MODIFICATION #10  
STREET 'E' MODIFIED SECTION  
**DEPARTMENT OF PUBLIC WORKS**

**Request for a  
Modification to a Road Standard  
and/or to Project Conditions**

Project Number: TM 5571/5572 Date of Request: January 31, 2014

ATTACHMENT 1  
WITH MODIFICATION #10  
STREET 'E'

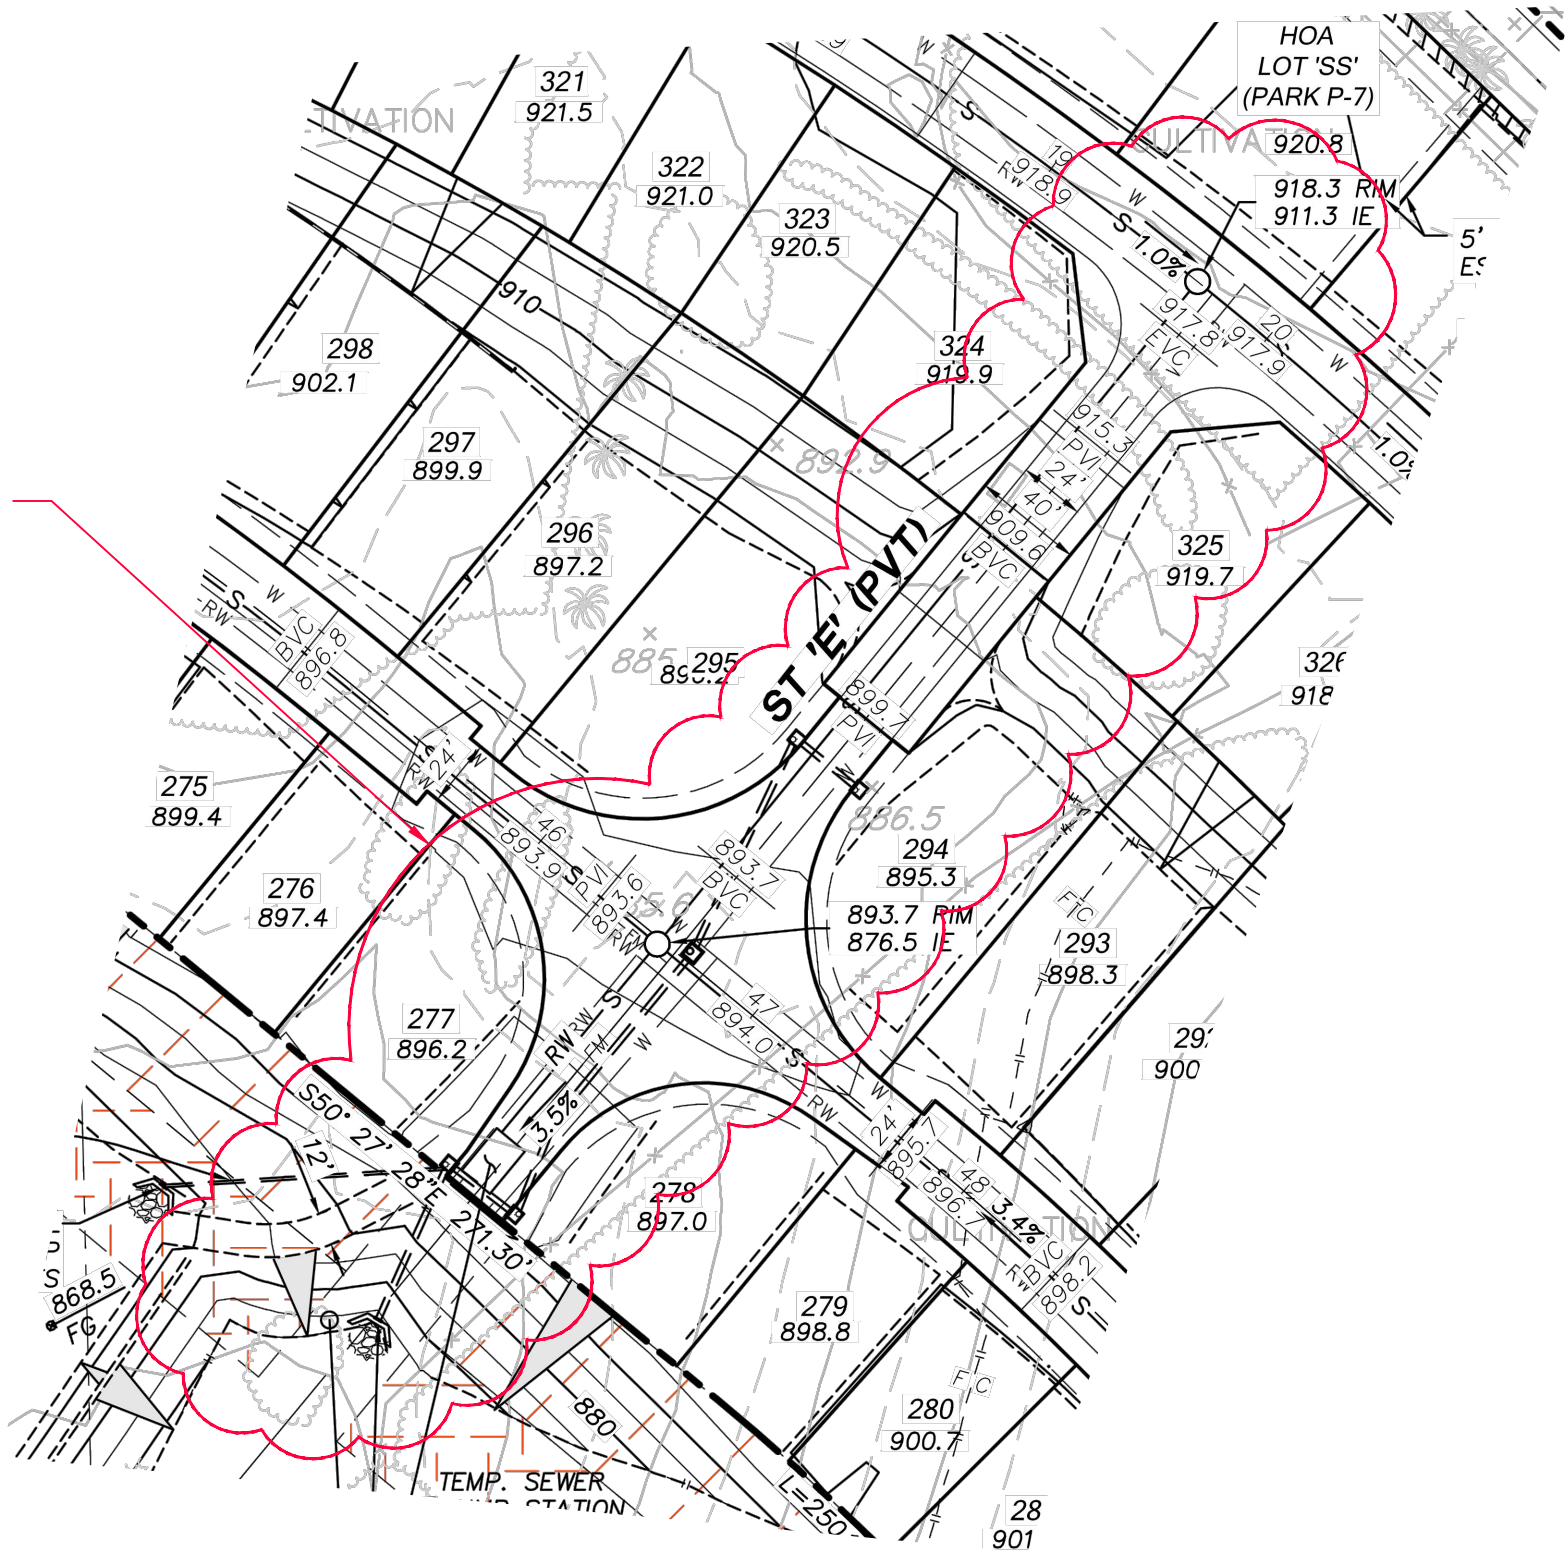
The standard road section for a Private Road is 24' paved width on 28' ROW with  
a minimum design speed of 25 mph. The requested modification to the road standard is  
to increase the paved width to 25' and increase the ROW to 34'. The design speed will  
be reduced to 20 mph.

THE DESIGN SPEED WILL  
BE REDUCED FROM 25 MPH TO 20 MPH.
